Verification of MELCOR Input Decks Used in ITER RPrS Analyses

INL/EXT-07-13305

This report as part of an ITER Task Agreement, documents the verification of the MELCOR Input Computer Decks used in performing the required safety analyses to be presented in the Preliminary Safety Report (Rapport Préliminaire de Sécurité, RPrS).

Figure 2-1 FW/BLK Model (failed loop) in Coolant Leak Port Cell Normal Deck

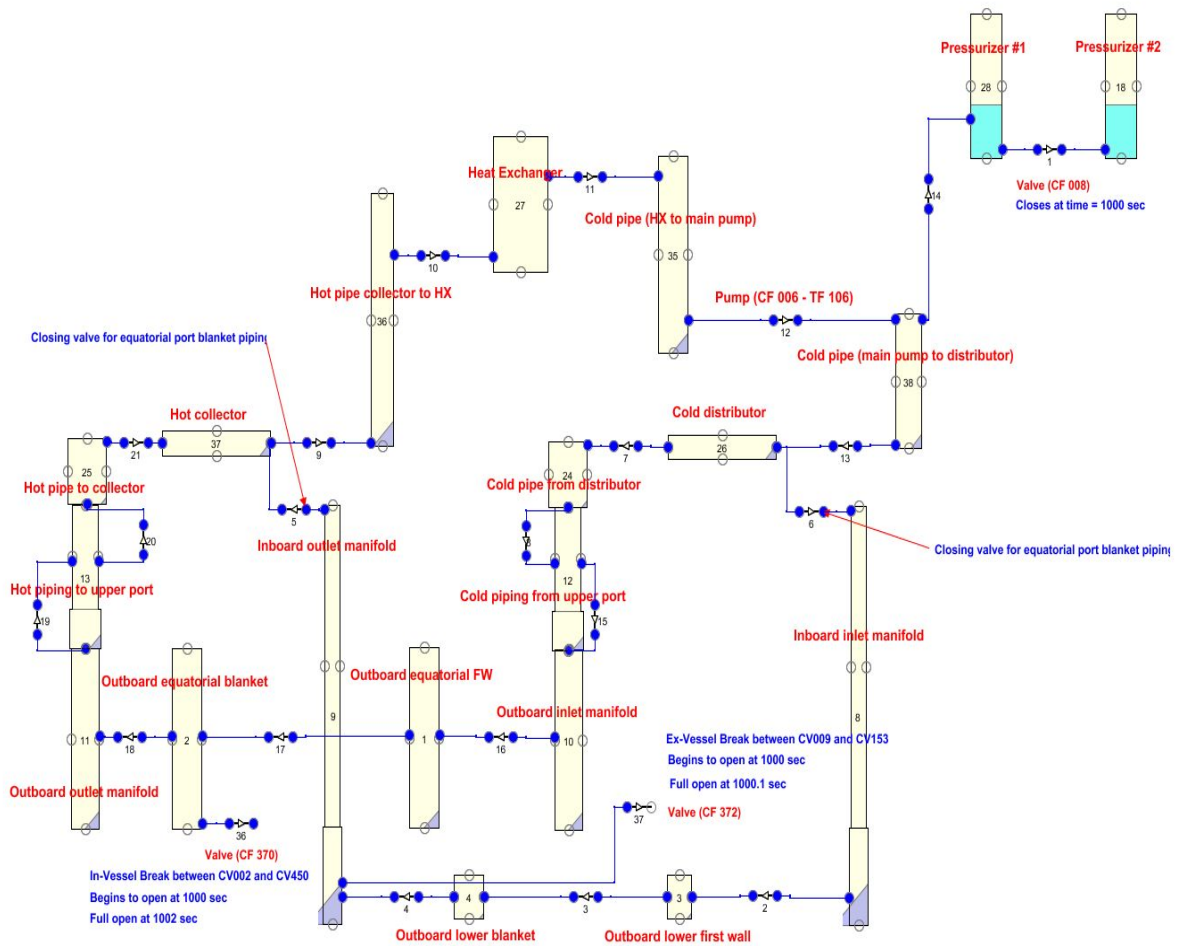
- 5) The lengths of FP f1007s1, f1009s1, f1013s2, f1021s2 (Figure 2.1) and FP f1905s2, f1906s1, f1909s1, f1913s2 (Figure 2.2) were determined to be incorrect in the original deck. Their lengths were decreased from 66 m to 33 m. Because of the reduction in lengths, the total length of f1007, f1009, f1013, f1021, f1905, f1906, f1909, and f1913 are 45.3m, 46.2 m, 49.1 m, 45.3 m, 45.3 m, 45.3 m, 46.2 m, 49.1 m respectively [Topilski07].

- 11) CF142 was changed. The original deck had a trip delay of 30 seconds associated with the valve (controlled by CF145) located in FP 5 and FP 6 (Figure 2.1). This trip delay was changed from 30 seconds to 60 seconds [AAS07].

- 27) The original deck had no in-vessel break from the FW/BLK to the plasma chamber as listed in AAS. FP 36 (Figure 2.1) was added to the latest deck to simulate the in-vessel break.

Figure 2-2 FW/BLK Model (two intact loops) in Coolant Leak Port Cell Normal Deck

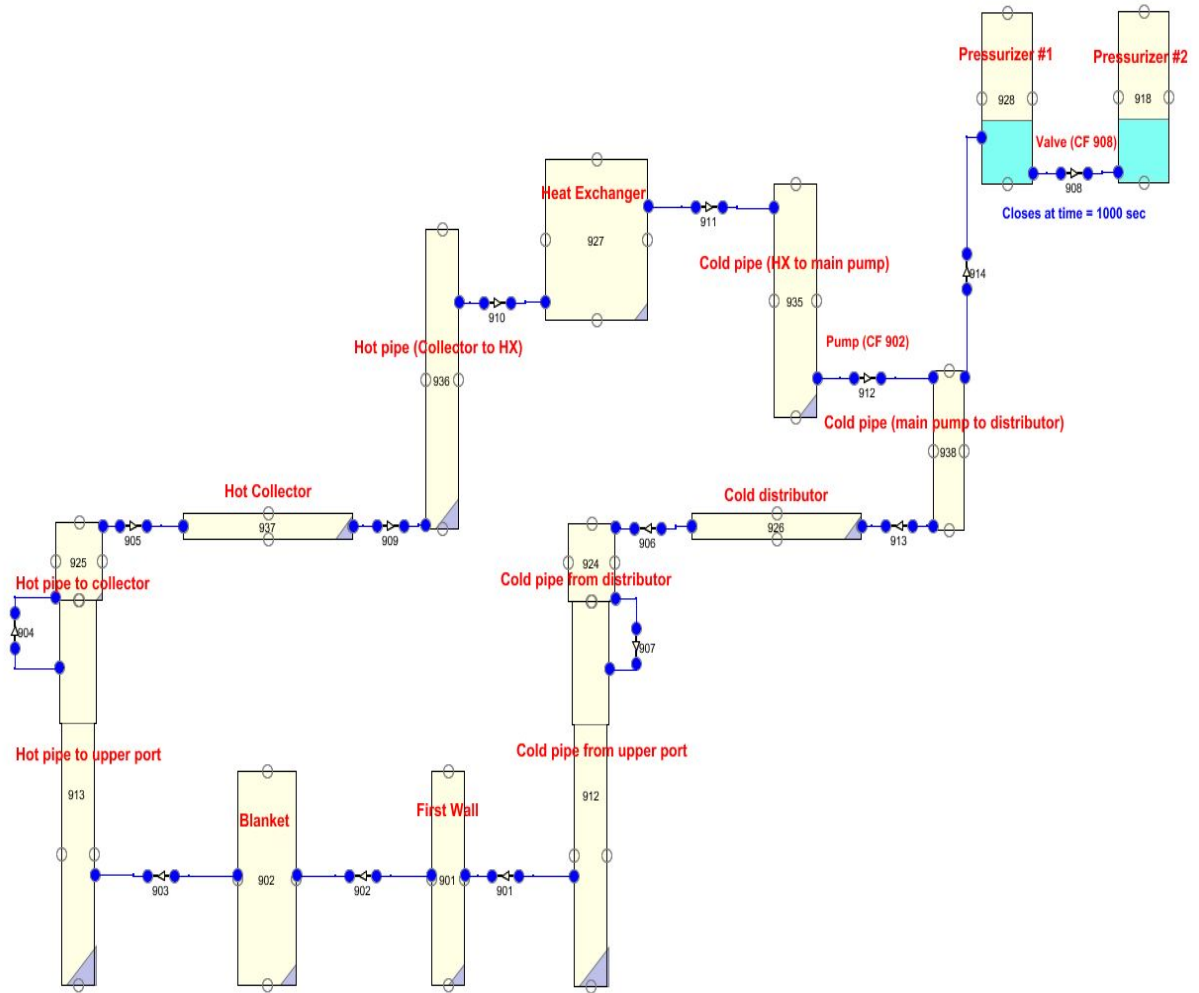
- 6) The hydraulic diameter of FP 908 (Figure 2.2) was determined to be incorrect in the original deck. It was changed from 0.122 m to 0.87 m.
- 7) Heat structures 912, 914, 924, 928, 930, 926, 932, 935, 936, 937, 938, and 939 were missing from the original deck but have since been added to the FW/BLK coolant loop (two intact loops) sub-model of the latest deck.

Figure 2-3 VV and Suppression System Model in Coolant Leak Port Cell Normal Deck

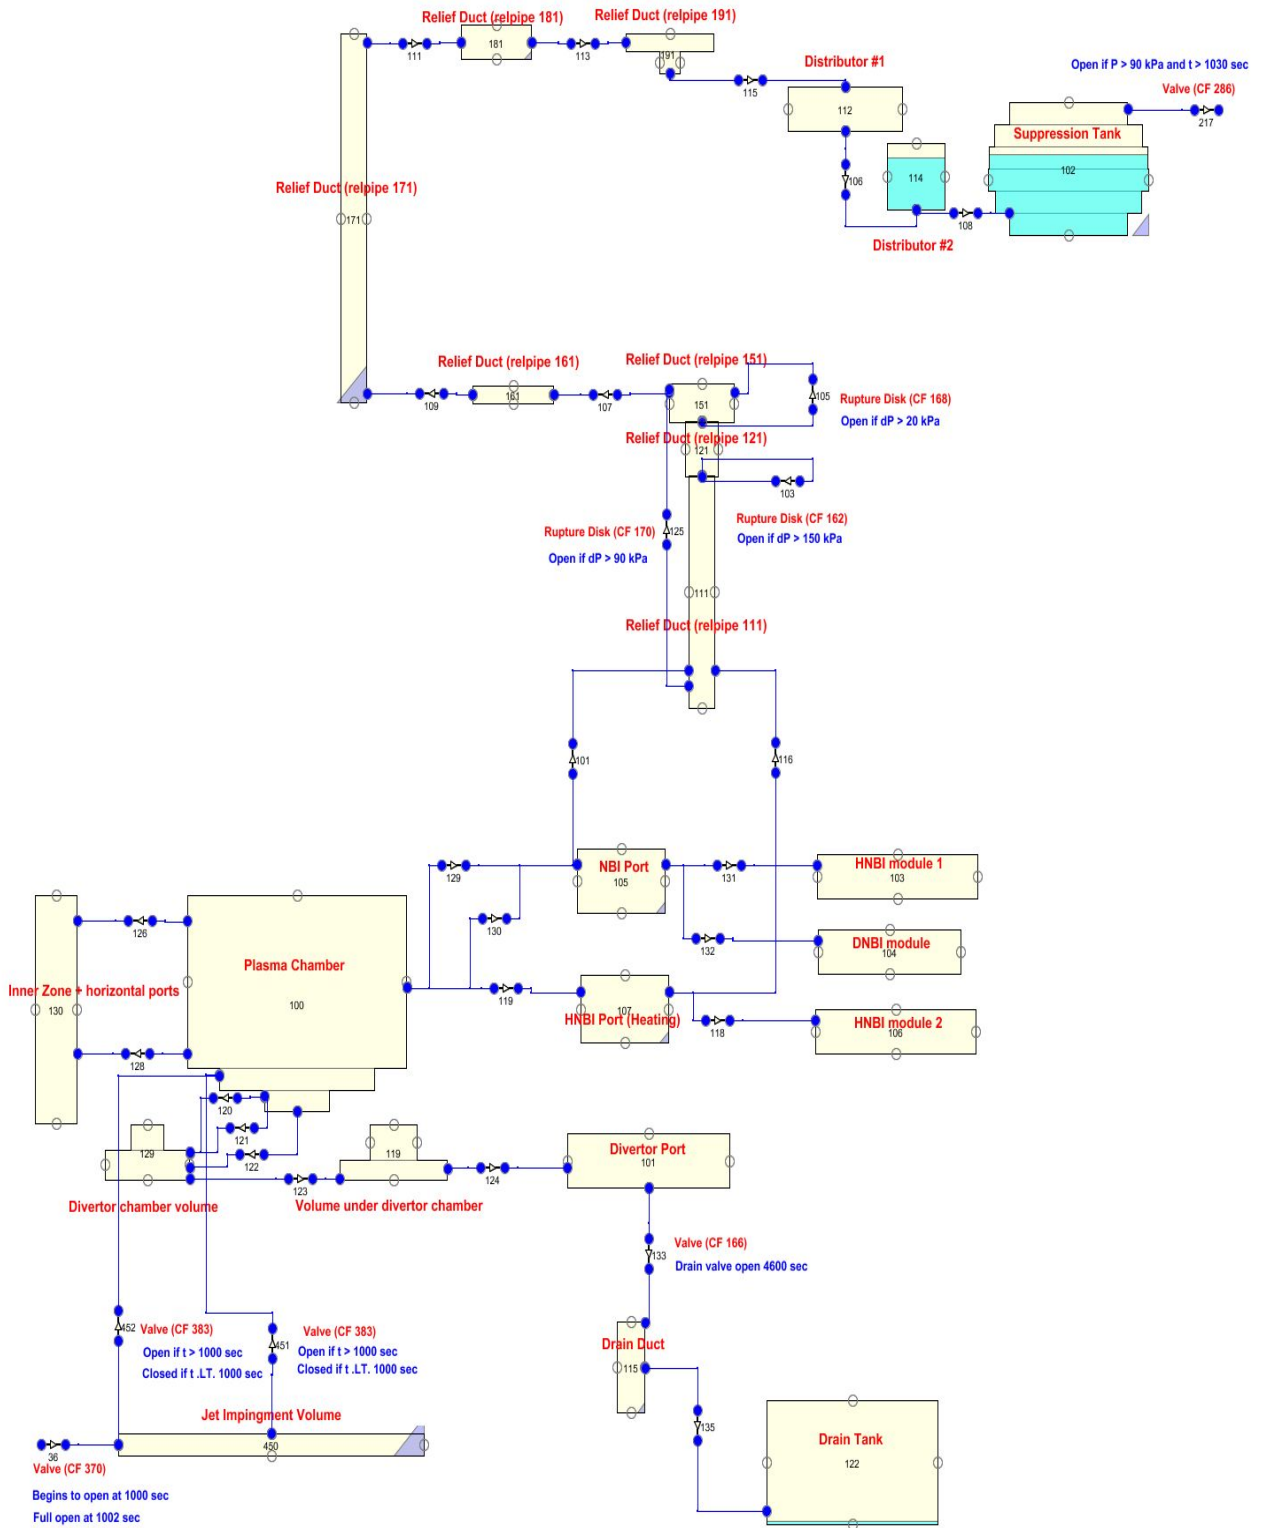
- 28) Jet impingement volume (CV450), FP from jet impingement volume to plasma chamber (FP 451 and 452 – Figure 2.3), heat structure representing the jet impingement target (HS450), and supporting control functions (CF450, CF451, CF452, CF453 and CF454) were added to the model since all break flows into the plasma chamber are assumed to impinge on the plasma chamber wall.

Figure 2-4 Confinement and Vent-Detrition Model in Coolant Leak Port Cell Normal Deck

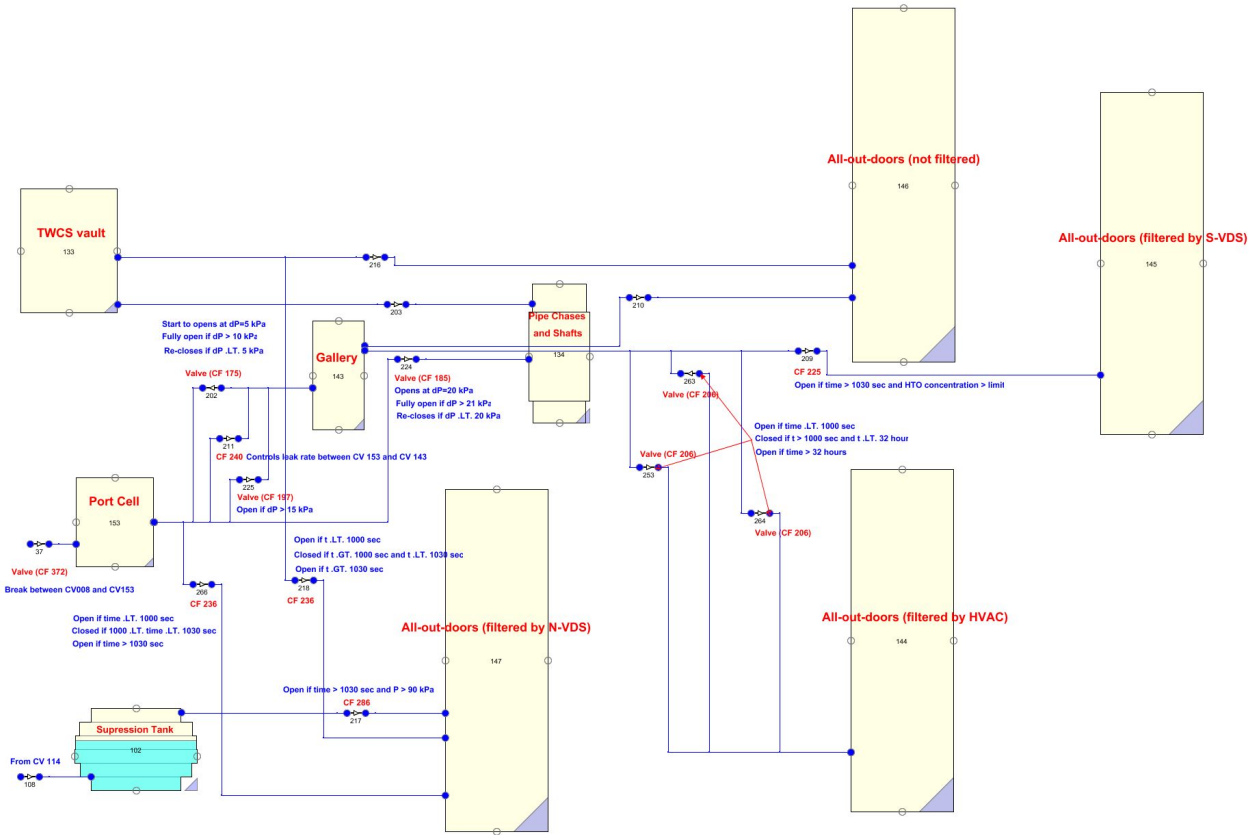
- 13) The volume of the TCWS vault (CV133 – Figure 2.4) in the original deck did not agree with the value listed in [SADL07]. The volume in the latest deck was changed from 22970 m³ to 23223 m³ to agree with the data in [SADL07].

- 14) The volume of the pipe chases and shafts (CV134 – Figure 2.4) in the original deck did not agree with the value listed in [SADL07]. The volume in the latest deck was changed from 16275 m³ to 14784 m³ to agree with the data in [SADL07].

- 24) The timing on the opening of the valve located in FP 209 (Figure 2.4) was change from 4600 sec to 1030 sec (CF225, Class III power). The opening time of this valve is a function of the parameter cases being run.

- 25) The timing on the opening of the valve located in FP 266 (Figure 2.4) was changed from 4600 sec to 1030 sec (CF236, Class III power). The opening time of this valve is a function of the parameter cases being run.

Figure 3-2 Simplified Divertor Loop Model in Coolant Leak Port Cell Bake Deck

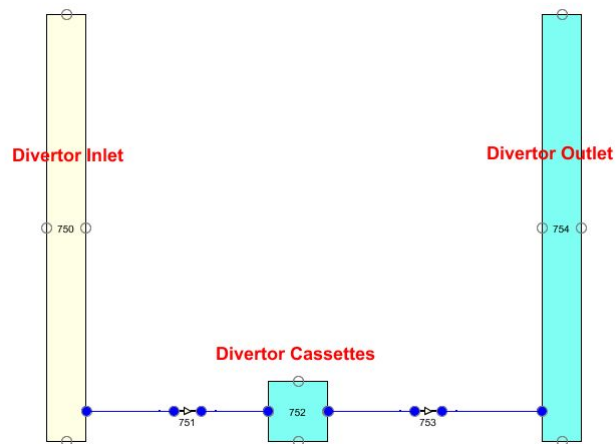
- 5) The hydraulic diameter of FP 901 (Figure 3.2) was determined to be incorrect in the original deck. It was changed from 0.122 m to 0.87 m.
- 6) The heat structure node number on control function CF91211 was changed from hs-temp.0090105 to hs-temp.0090106. Node 06 (not node 05) is the exterior node of heat structure 00901 which faces node 01 of hs-temp.00904.

Figure 4-1 FW/BLK Model (failed loop) in Cryostat Water Ingress Deck

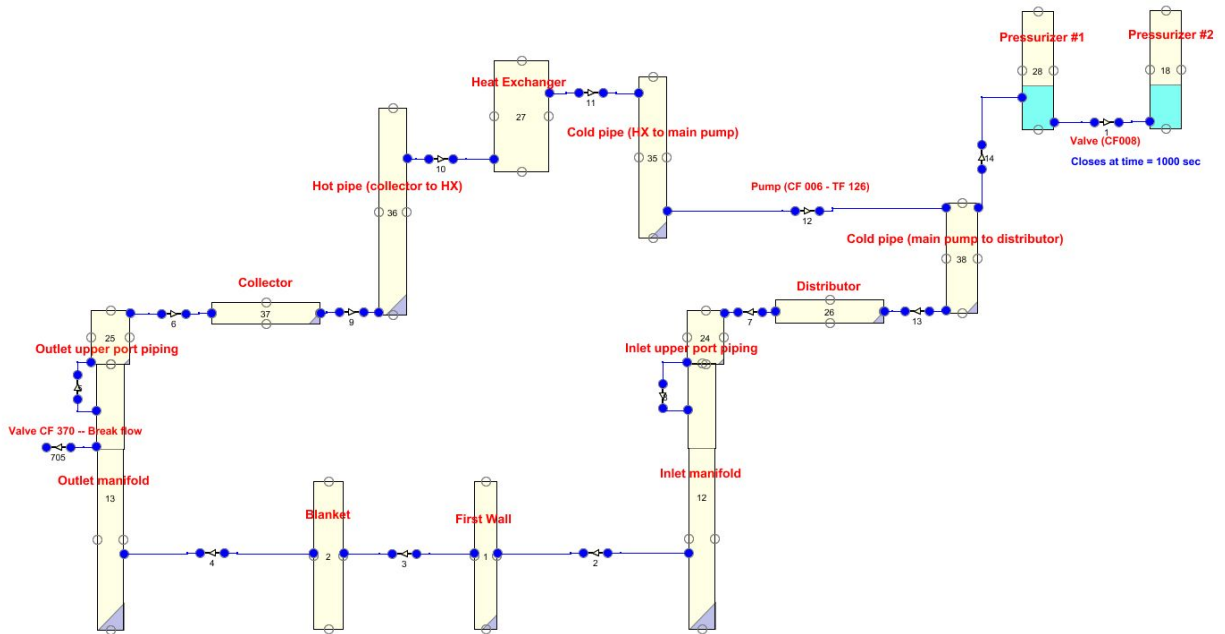
- 1) See item 1 – section 2.
- 2) In the original deck the valve (Figure 4.1) located between pressurizer #1 and pressurizer #2 was programmed to remain open during the entire transient time. The valve should be programmed to isolate pressurizer #1 from pressurizer #2 at the time the accident is initiated (1000 seconds). This change now appears in the 11/27/07 deck.

- 3) The lengths of FP f1006s2, f1007s1, f1009s1, f1013s2 (Figure 4.1) and FP f1906s2, f1907s1, f1909s1, f1913s2 (Figure 4.2) were determined to be incorrect in the original deck. Their lengths were decreased from 66 m to 33 m. Because of the reduction in segment lengths, the total lengths of f1006, f1007, f1009, f1013, f1906, f1907, f1909, and f1913 are 45.3m, 46.2 m, 49.1 m, 45.3 m, 45.3 m, 46.2 m, 45.3 m, 49.1 m respectively [Topilski07]. These changes now appear in the 11/27/07 deck.

Figure 4-2 FW/BLK Model (two intact loops) in Cryostat Water Ingress Deck

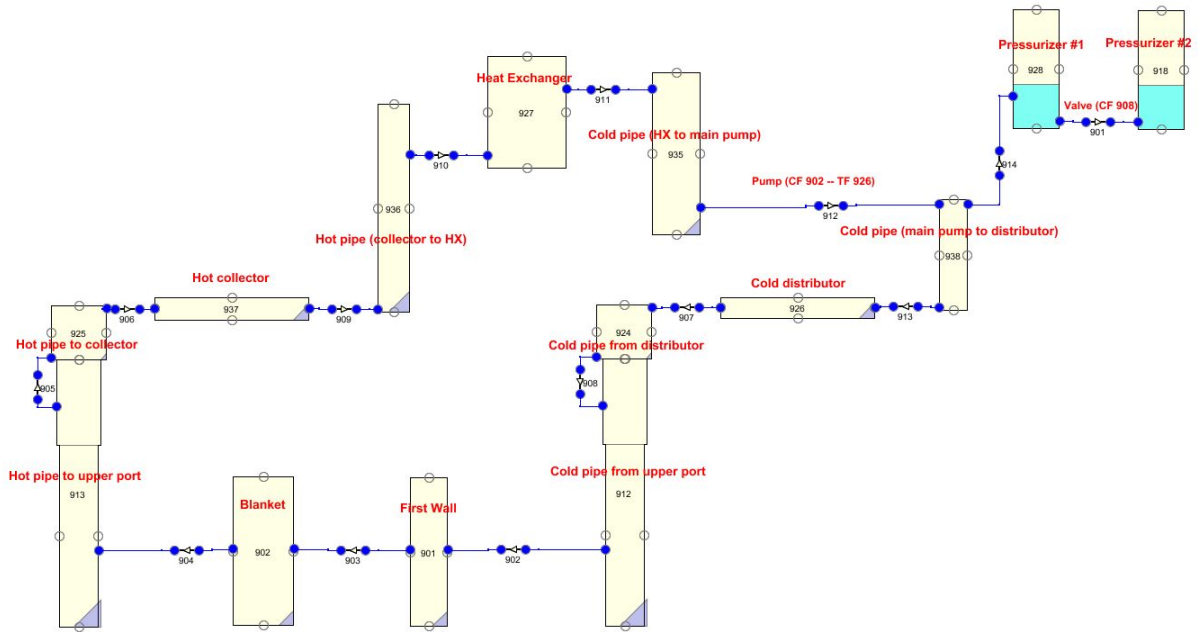
- 7) One of the cards associated with CV918 (Figure 4.2) input has a typo error. The card as given is **cv94801 0 -1**. The card should read as **cv91801 0 -1**. This change now appears in the 11/27/07 deck.

Figure 4-4 Cryostat Model in Cryostat Water Ingress Deck

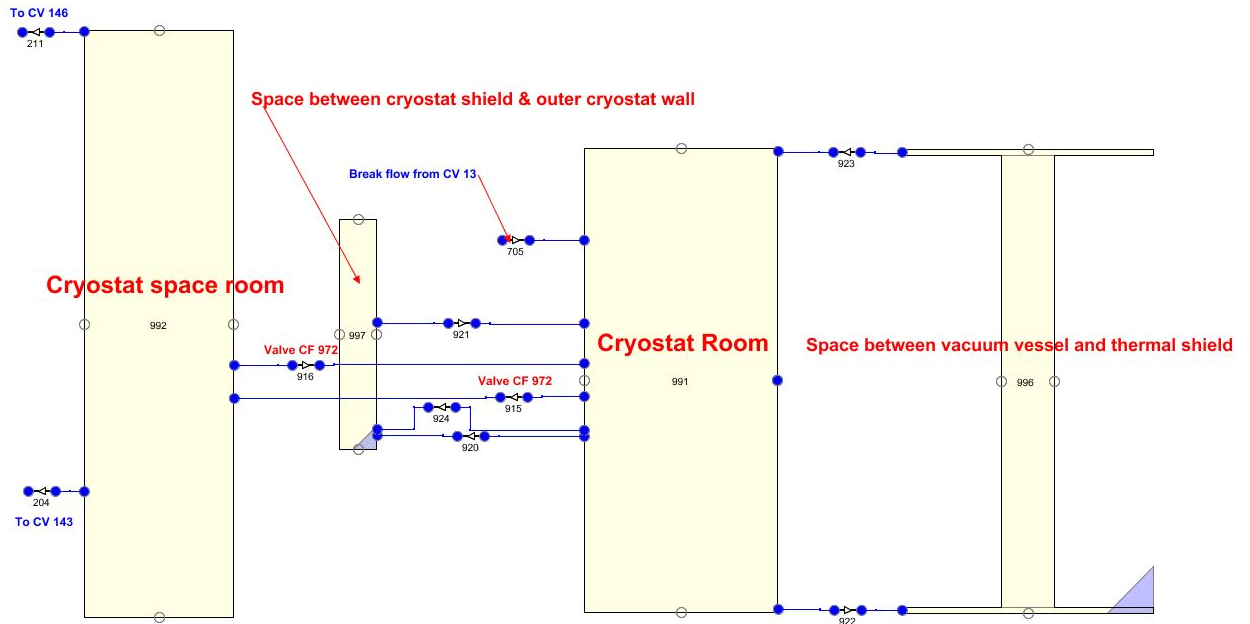
- 10) In the original deck, the initial atmosphere in the cryostat room (CV991 – Figure 4.4) was represented by helium. In the 11/27/07 deck, the atmosphere has been changed to nitrogen to represent air.

- 13) In the original deck the break into the cryostat room was from CV701 (VVPHTS) to CV991 (cryostat room), however [AAS07] states that the break should be from the FW/BLK coolant loop to the cryostat room. The 11/27/07 deck now has the break from CV013 of the FW/BLK coolant loop to the cryostat room through FP 705 (Figure 4.4).

Figure 5-1 FW/BLK Model (three intact loops) in Large Divertor Ex-Vessel Pipe Break Deck

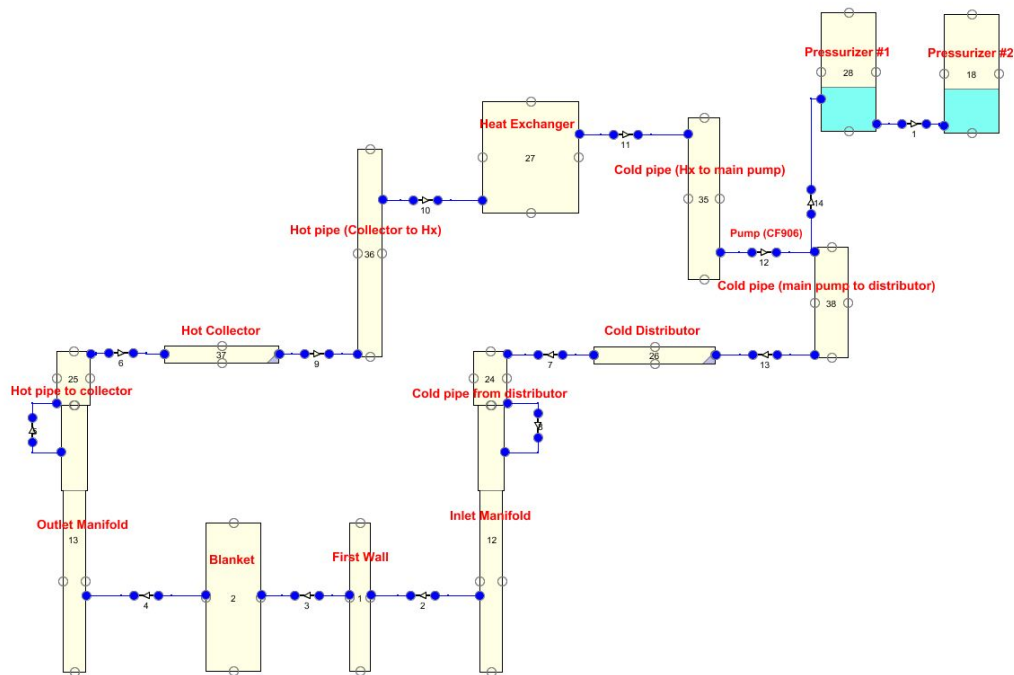
- 3) The lengths of FP fl006s2, fl007s1, fl009s1, and fl013s2 (Figure 5.1) were determined to be incorrect in the original deck. There lengths were decreased from 66 m to 33 m. Because of the reduction in segment lengths, the total lengths of fl006, fl007, fl009, fl013 are 45.3 m, 46.2 m, 49.1 m, 45.3 m, respectively [Topilski07]. These changes now appear in the 11/27/07 deck.

Figure 5-3 Confinement and Vent-Detrition Model in Large Divertor Ex-Vessel Pipe Break Deck

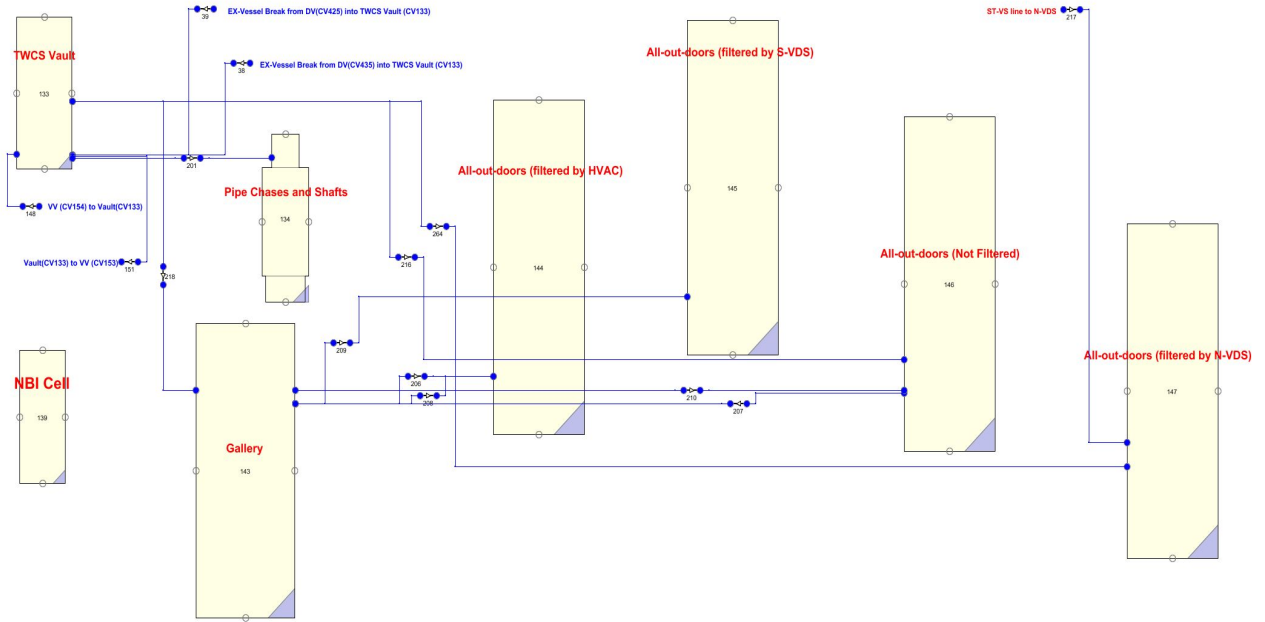
- 5) The volume of the TCWS vault (CV133 – Figure 5.3) in the original deck did not agree with the value listed in [SADL07]. The volume in the latest deck was changed from 22970 m³ to 23223 m³ to agree with the data in [SADL07].

- 6) The volume of the pipe chases and shafts (CV134 – Figure 5.3) in the original deck did not agree with the value listed in [SADL07]. The volume in the latest deck was changed from 16275 m³ to 14784 m³ to agree with the data in [SADL07].
